State of California  
AIR RESOURCES BOARD

Notice of Public Availability of Modified Text

PUBLIC HEARING TO CONSIDER ADOPTION OF AMENDMENTS TO REGULATIONS REGARDING  
EVAPORATIVE EMISSION STANDARDS AND TEST PROCEDURES APPLICABLE TO 1995 AND  
SUBSEQUENT MODEL-YEAR PASSENGER CARS, LIGHT-DUTY TRUCKS, MEDIUM-DUTY  
VEHICLES AND HEAVY-DUTY VEHICLES

Public Hearing Date: February 10, 1994  
Public Availability Date: June 21, 1994  
Deadline for Public Comment: July 6, 1994

FIGURE 2. TEST PROCEDURES FOR 1995 MODEL MOTOR VEHICLES.

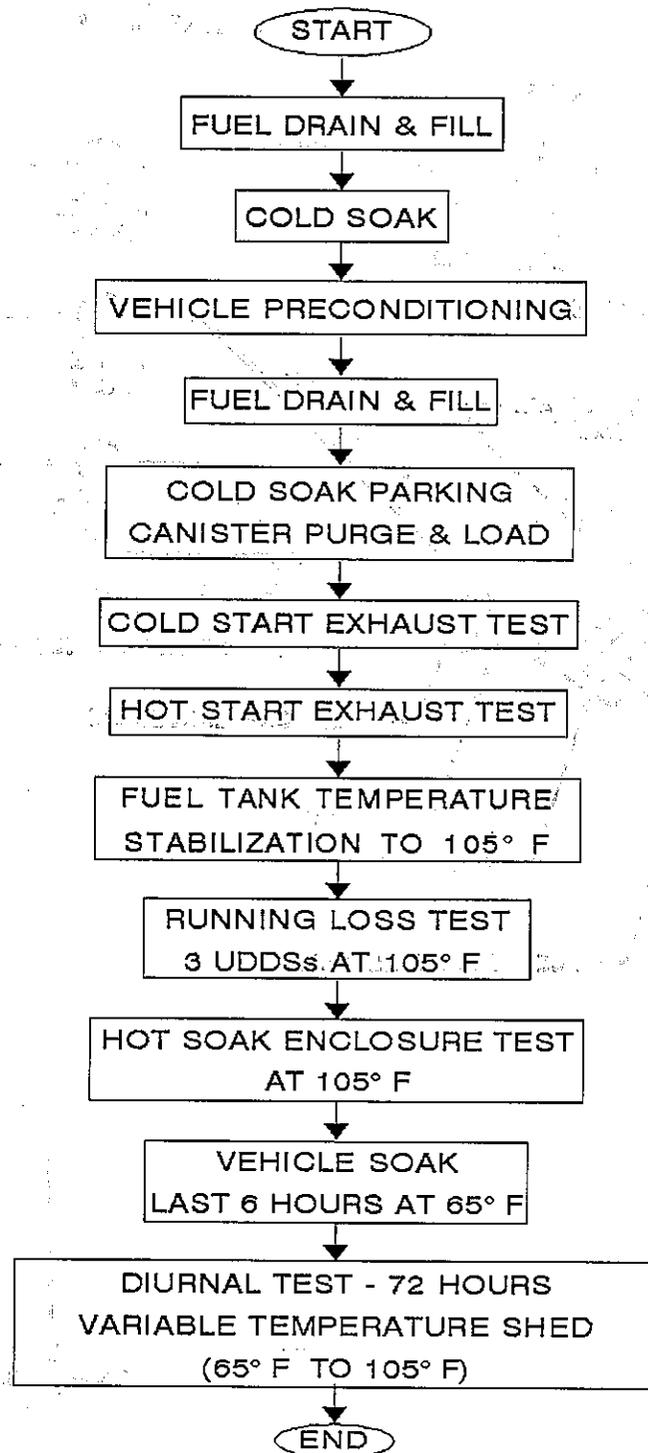
For 1993 to 1995 model hybrid electric vehicles and 1995 model motor vehicles, the test sequence shown in Figure 2 (Figure 3 for hybrid electric vehicles) describes the steps encountered as the vehicle undergoes the procedures the three-day diurnal sequence to determine conformity with the standards set forth. For 1996 and subsequent model motor vehicles, the test sequence shown in Figure 4 (Figure 5 for hybrid electric vehicles) describes the steps encountered as the vehicle undergoes the three-day diurnal sequence and the supplemental two-day diurnal sequence to determine conformity

The three-day diurnal test sequence shown in Figure 2 (and Figure 3 for hybrid electric vehicles) is briefly described as follows:

FIGURE 3. TEST PROCEDURES FOR 1993 TO 1995 MODEL HYBRID ELECTRIC VEHICLES

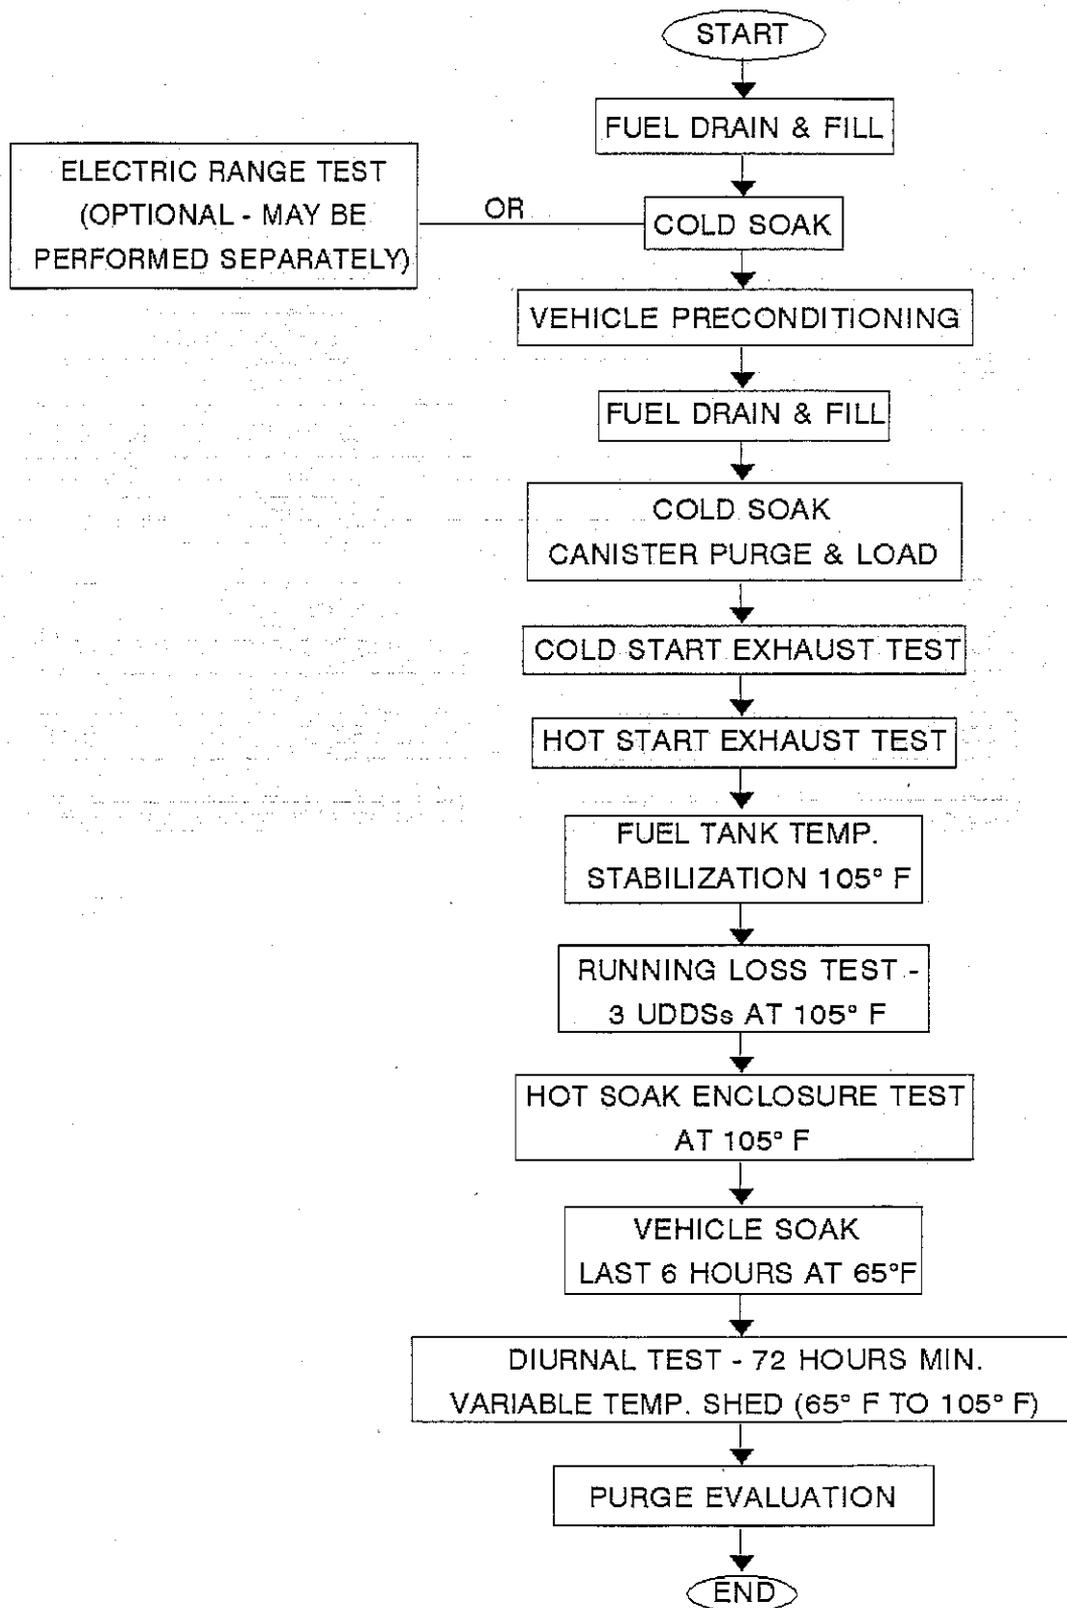
[This is a new figure proposed to be added to the test procedures.]

FIGURE 4. TEST PROCEDURES FOR 1996 AND SUBSEQUENT MODEL MOTOR VEHICLES

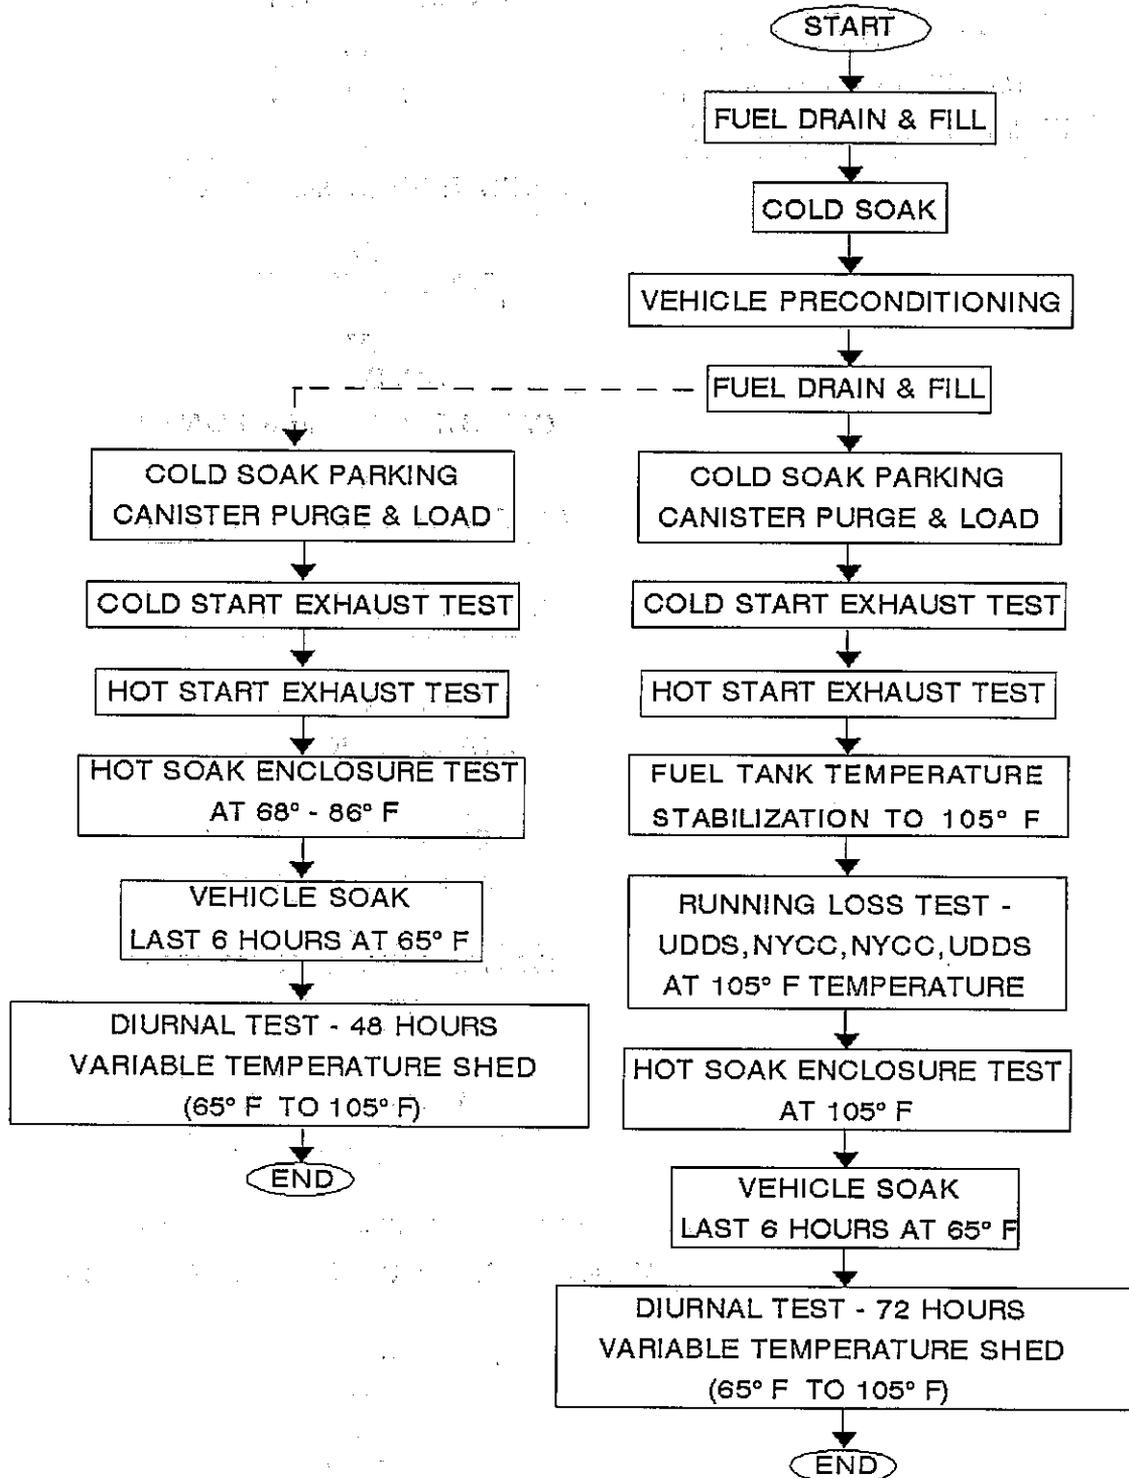
i. . . For 1996 and subsequent model motor vehicles, the test sequence shown in Figure 4 (Figure 5 for hybrid electric vehicles) describes the steps encountered as the vehicle undergoes the three-day diurnal sequence and the supplemental two-day diurnal sequence to determine conformity with the standards set forth. Methanol measurements may be omitted when methanol-fueled vehicles will not be tested in the evaporative enclosure.

The supplemental two-day diurnal sequence in Figure 4 (and Figure 5 for hybrid electric vehicles) shall be conducted according to the steps described in (A) through (G), followed by (J) through (L) of this paragraph except that the ambient temperature of the hot soak test is conducted at an ambient temperature between  $68^{\circ}\text{F}$  and  $86^{\circ}\text{F}$  at all times and that the diurnal test will consist of a two-day test.

[This is a new figure proposed to be added to the test procedures.]
